Packet Guide
City of Charlottesville
Board of Architectural Review
Regular Meeting
August 16, 2022, 4:00 p.m. (pre-meeting) and 5:30 p.m.
Hybrid Meeting (In-person at CitySpace and virtual via Zoom)

Special meeting: Review materials for Courts Expansion, Levy Site. No action to be taken.

Project: New courthouse building (at Levy Building)

Project: Install grates at three mall fountains

[Sketches by BAR staff. For discussion only.]

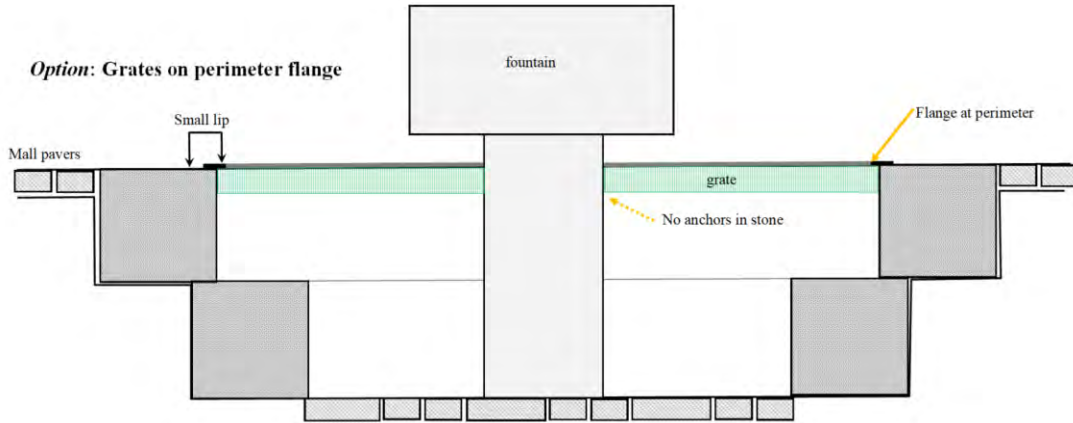
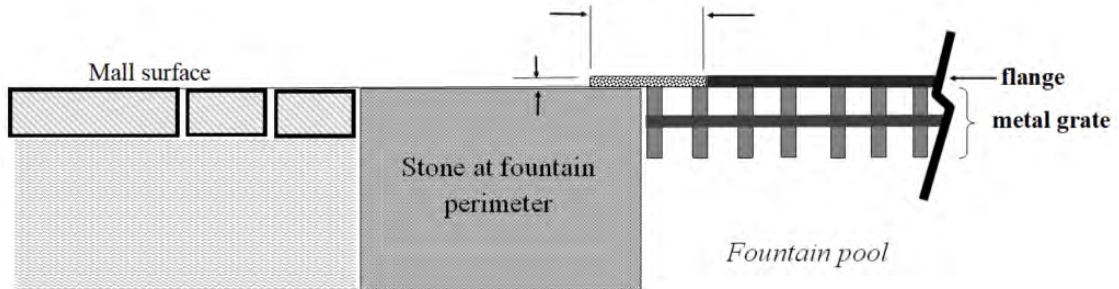
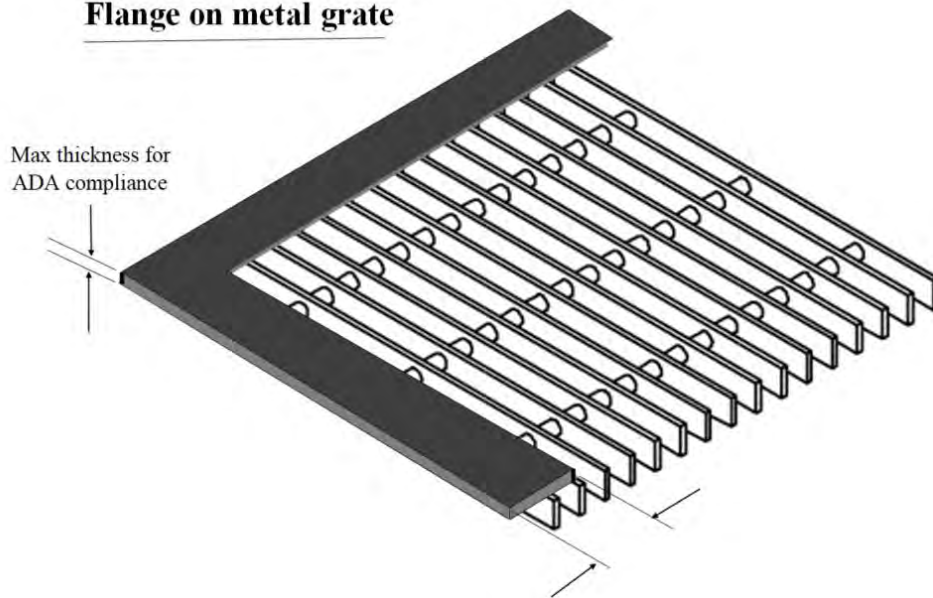
- The grates be fabricated such that installation does not require boring anchors into the existing stone. For ex, the grates would be supported by a metal flange at the perimeter (see below).
- The grates are deemed temporary for a period of one (1) year [following installation], with the understanding that pedestrian safety at all of the Mall’s fountains will be evaluated during the City’s planned stakeholder discussions and any proposed changes will be presented to the BAR.
